October 21, 2022

Subject: Review of Temporary Point of Compliance (TPOC) Status 5-Year Notice for:
Lockheed Martin Tallevast Site
1600 Tallevast Road
Sarasota, Florida
FDEP Site No. ERIC_11531/Project No. 238148
RES Project Number 1-1440-005

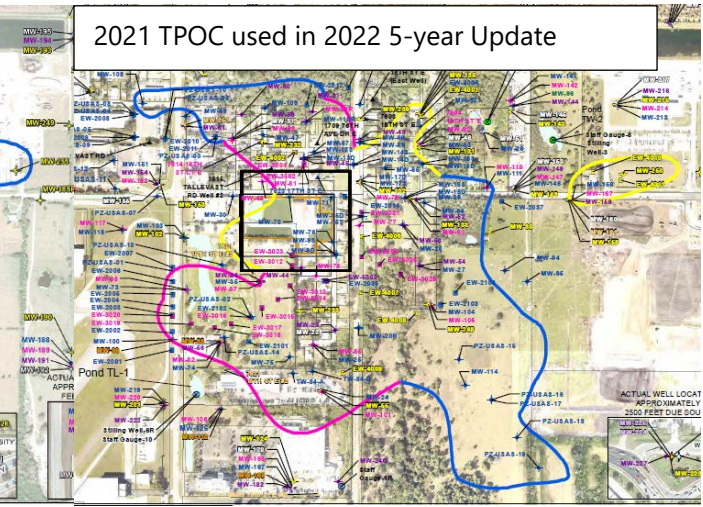
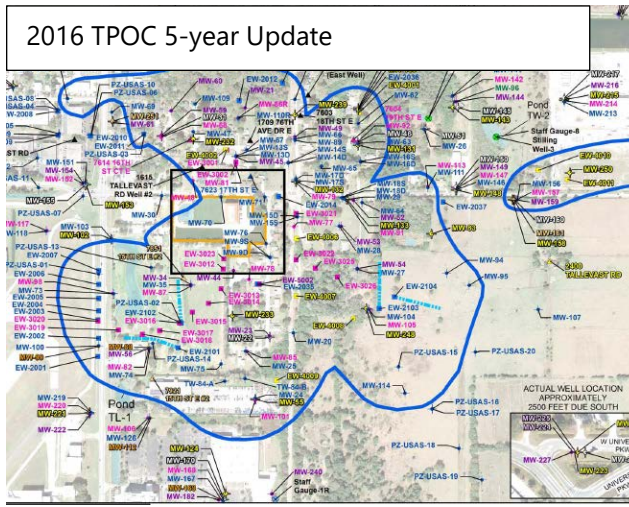
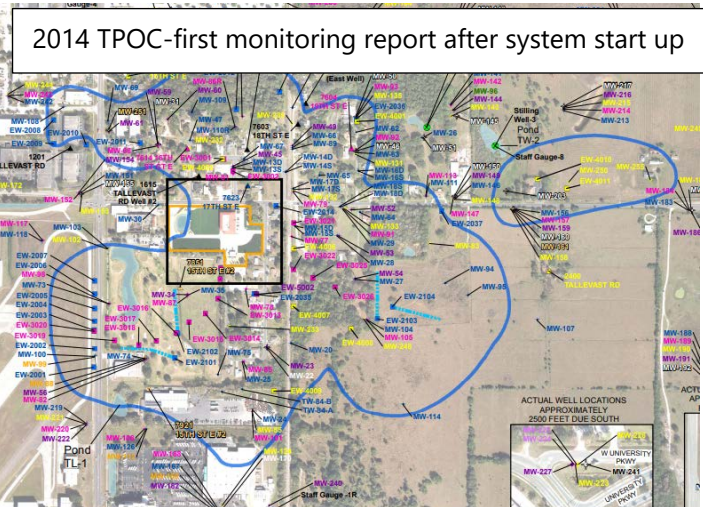
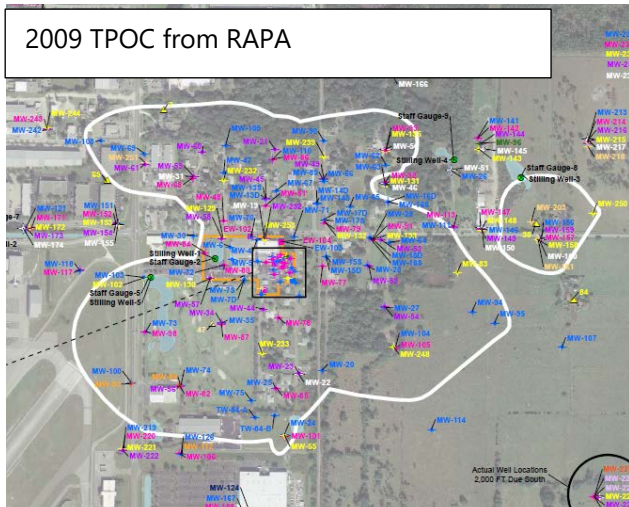
- **The TPOC has been modified multiple times as the plume has expanded confirming that the RAP as approved was ineffective in containing the plume.** After the 2010 RAPA approval order was issued, we expressed concerns that the 2009 TPOC was based upon insufficient assessment data and therefore the adequacy of the approved RAP design could not be properly evaluated. One example given was that the southeastern boundary of the TPOC was drawn between two USAS monitoring wells that were more than 600 feet apart: specifically, clean monitoring well MW-114 and contaminated monitoring well MW-104. By 2011, 1,4-dioxane was regularly detected above the standard in samples collected from MW-114, indicating that the contamination plume was likely larger than anticipated during the preparation of the RAP and the initial TPOC that was sent with notices to affected parties. Lockheed Martin has had to adjust the TPOC accordingly in subsequent years as additional assessment required by FDEP revealed that the lateral extent of the plume is much larger than initially defined and accepted. Over time, data collected through Lockheed Martin’s remedial action effectiveness monitoring confirmed our concern that the plume was not delineated but also that it was not being contained and recovered by the approved remediation system. Valuable time was lost as the plume continued to spread unaffected by the remediation system.

- **The TPOC is to be established at the SAR or RAP stage and not be regularly revised.** Florida statute 376.30701 acknowledges that in some cases a plume is known to extend off a source property but authorizes the FDEP to extend the point of compliance beyond the source area **temporarily**, while cleanup is underway. The TPOC may only be moved beyond the property boundary to address conditions of the plume and therefore may not be extended further than the plume at the time of the site assessment or RAP approval order. FS 376.301(47) defines the TPOC as the boundary represented by one or more designated monitoring wells at which GCTLs may not be exceeded while site rehabilitation is proceeding. Essentially, the TPOC is an acknowledgement that the Responsible Party has identified the edge of the contamination plume and is given leeway to conduct cleanup within that TPOC with the understanding that the plume will be contained and mitigated through remediation efforts. The purpose of setting the TPOC is defining the starting extent of the contamination and the intent is to remediate the contamination within, and therefore reduce the TPOC boundaries. However, Lockheed Martin has been granted the ability to continually extend the TPOC each time they identify monitoring wells with contamination exceeding GCTLs while site rehabilitation is proceeding. This should be considered to be a violation of the TPOC, which should trigger evaluation of the effectiveness of the remediation system. The following snips show snapshots of the TPOC changes over time as documented in Lockheed Martin reports.
